**Town of Kittery  
 Planning Board Meeting  
 October 13, 2022**

**28 Wyman Avenue — Sketch Plan Review, Cluster Residential Subdivision**

**RE: Town of Kittery, Planning Board Services  
Wyman Hill Cluster Subdivision  
28 Wyman Avenue, Tax Map 16, Lot 148  
CMA #591.151**

**EXISTING CONDITIONS PLAN**  
 FOR PROPERTY AT  
**28 Wyman Avenue**  
 Kittery, York County, Maine  
 OWNED BY  
**Lusitano, LLC**  
 Attn: Jim Higgins  
 119 Kings Highway No., Eliot, ME 03903

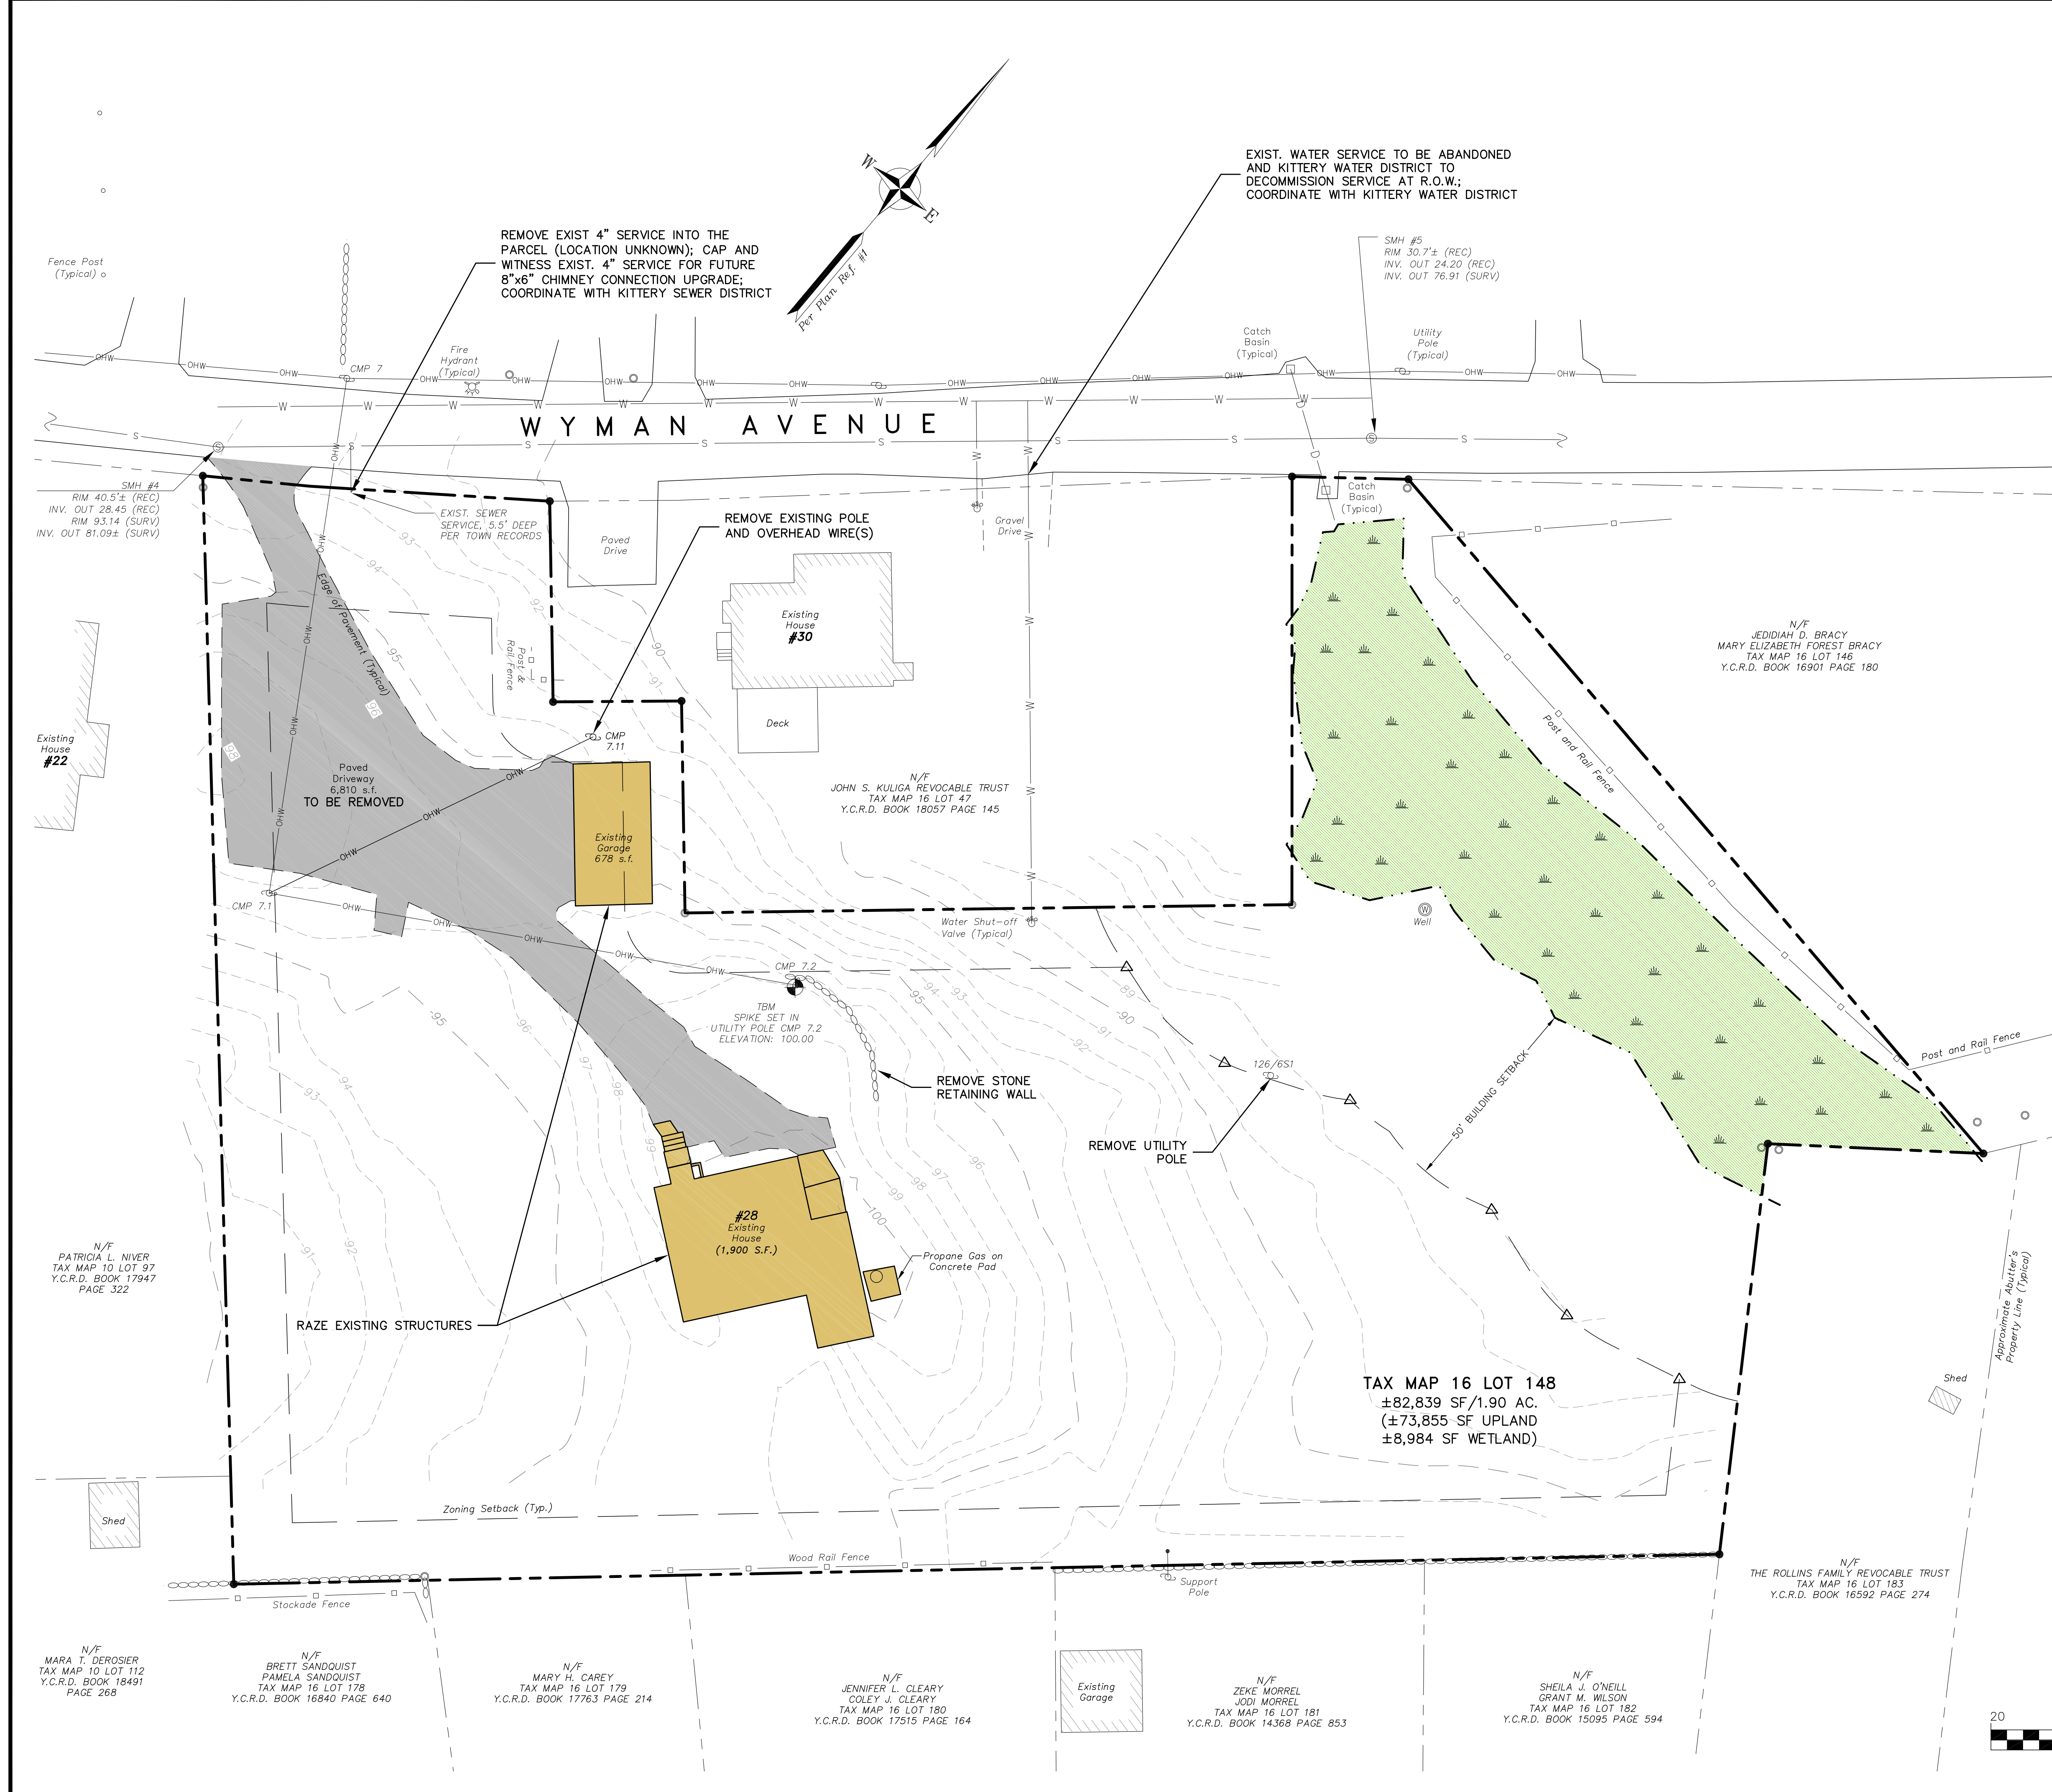
- The asterisks next to the minimum rear and side yards and maximum building height in the Zoning Data per Kittery Zoning Ordinance table should be defined.
- Please provide a note regarding wetland delineation and have the wetland scientist stamp the plans.
- Existing utilities sizes and materials should be shown on the plan.
- Existing structures rim and invert elevations should be shown on the plan.

SHEET NUMBER:  
**C - 1**

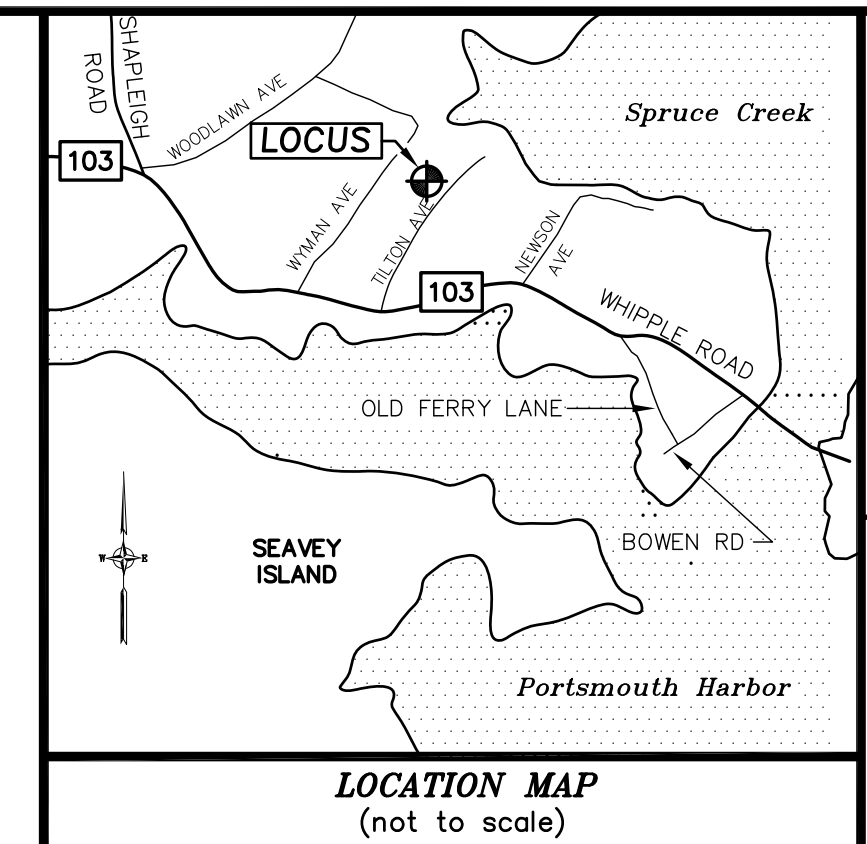
- Add Kittery Water District to Note 5.
- Note 6 does not apply to this project.
- Is the post and rail fence to remain?
- The plan should include a legend.
- Was a test pit completed on site? Where is the test pit log?
- Remove the wetland buffer markers from the plan.

SHEET NUMBER:  
**C - 2**

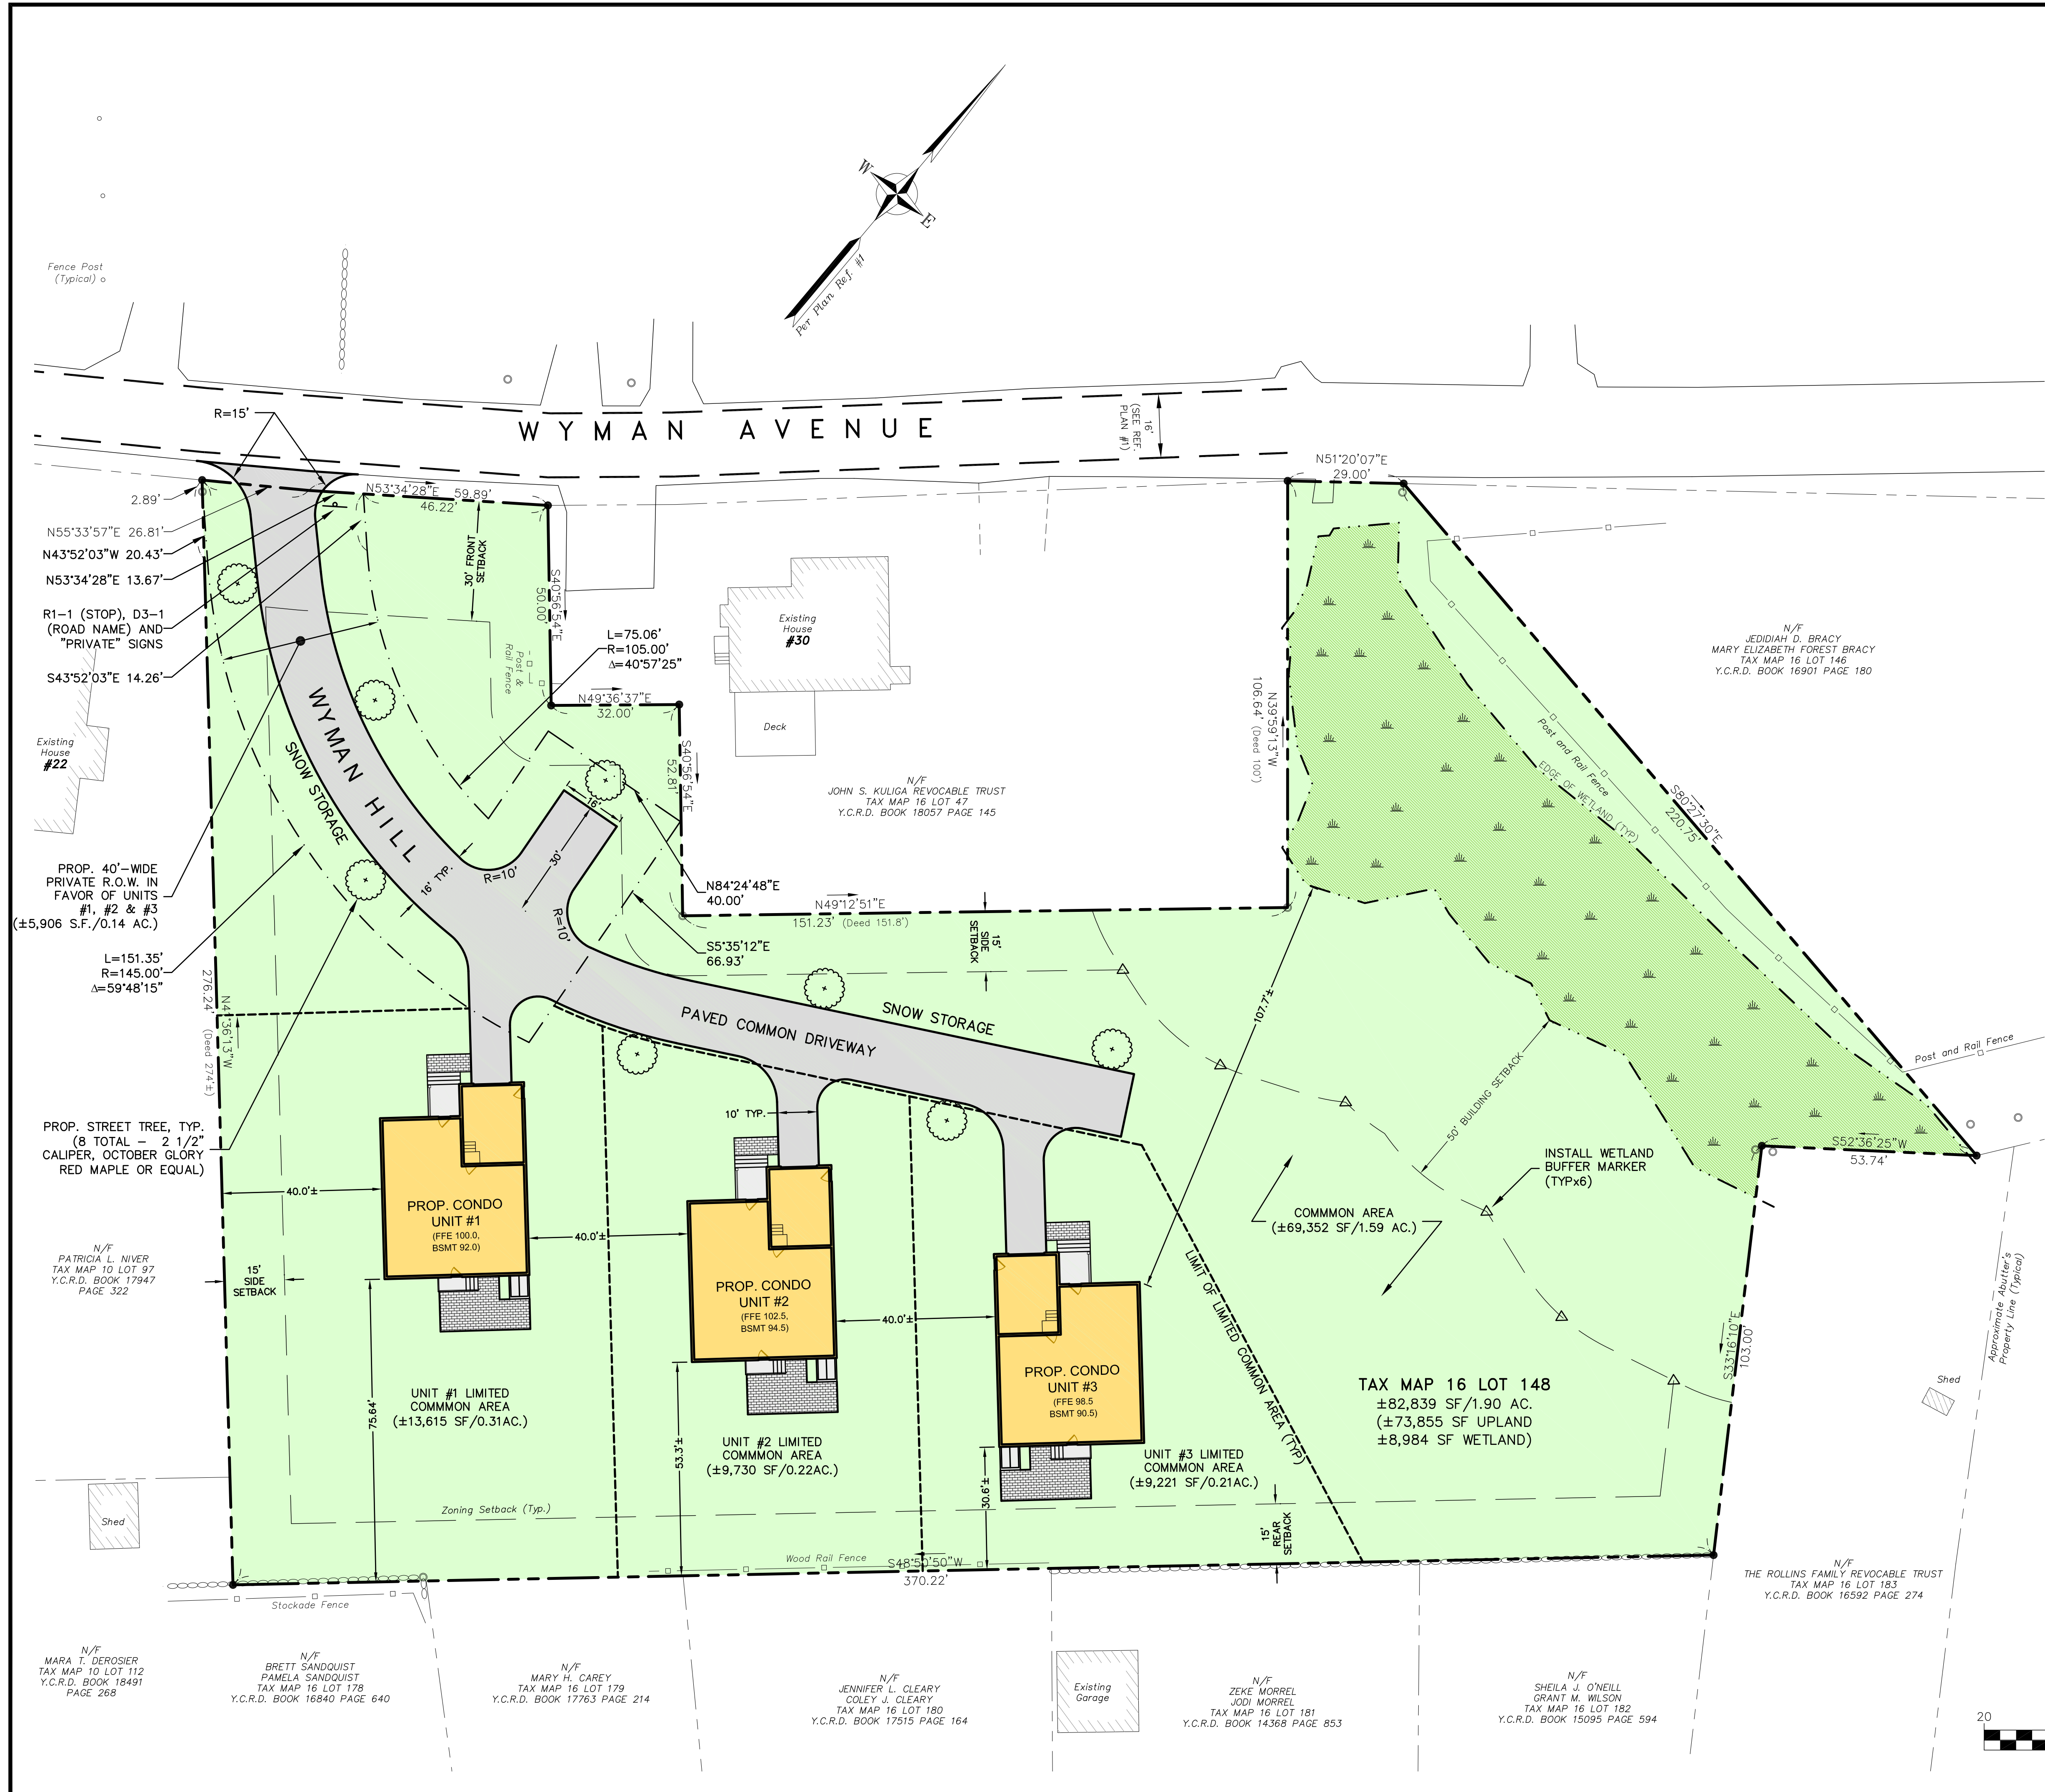
50 **Update:** The plan highlights a “Common Area” green space on sheet C-2 with the addition of where the  
51 50-foot wetland buffer markers will be installed. The common area will serve the three residences of the  
52 condominium development.  
53

85 [2] *Constraints to development* – shown on C-2

- The large turnaround tee is located before the last houses. The applicant should provide turning movements to show that a fire truck can turnaround at the tee located beyond Unit #3.
- Why does the 40' private ROW change to a shared driveway?
